RE: **Case Closure for Underground Storage Tank Site,  
2401 Encinal Avenue, Alameda, Alameda County,  
County File: STID 3948**

Re: Alameda Fire Department, located at 2401 Encinal Avenue,  
Alameda, California

**RECOMMENDATION FOR UST CASE CLOSURE**

UNDERGROUND TANK CLOSURE/MODIFICATION PLANS

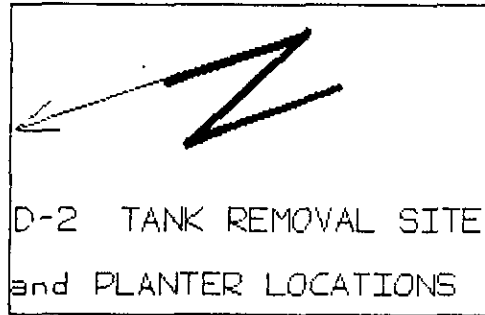
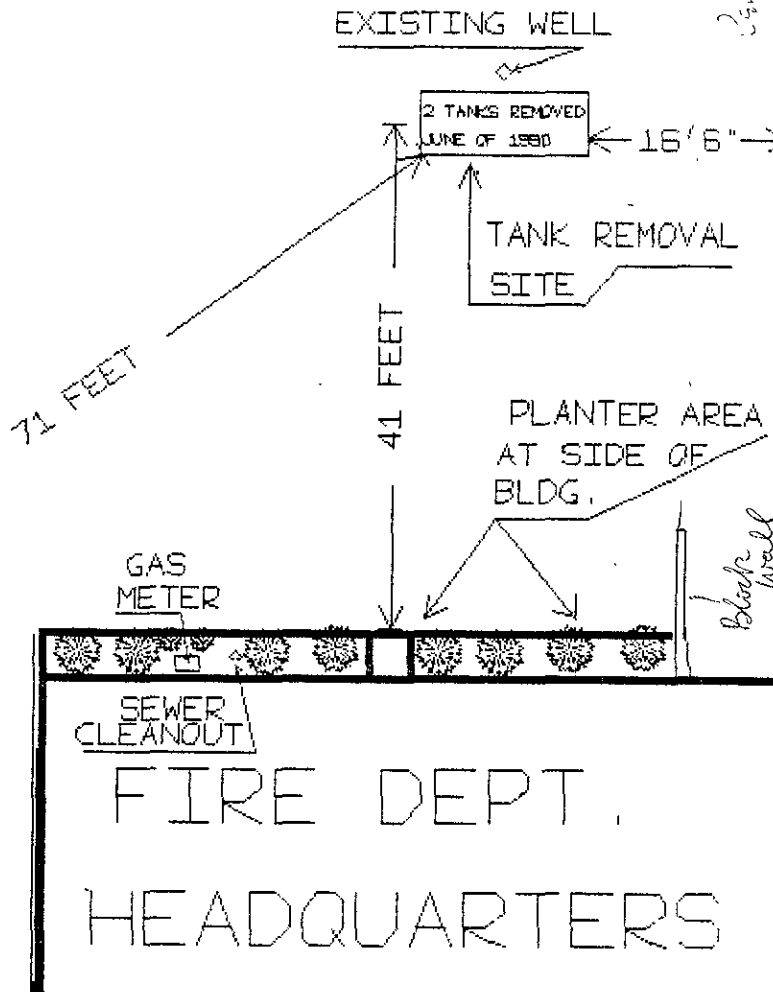
Enclosed you will find the computer generated drawing relating to the tank removal site. Drawing number D-1 depicts the site plan of our property. Drawing D-2 shows the site where the fuel tanks were removed in 1990 as it relates to the buildings and planter area that we discussed. Drawing D-3 is a drawing of the planter area that is adjacent to the Headquarters office building. As you can see in drawing D-3 the area has limited access for a truck mount drill rig. As we discussed there are utilities that are present in the planter area. We have located pipe or pipes in the planter within the area of clearance. To date we have not been able to determine which utility the pipes serve, and it doesn't really matter; the pipes are present.

An alternative is to bore at the planter area next to the Park St. driveway which is seventy feet to the North, North/West of the removal site. One other option is to wait until later this year. We are tentatively planning the construction of a generator pad which will cause us to remove some asphalt and redo the vapor/soils matting in that area. The problem is that the construction site will be sixty feet to the East of the tank removal site.
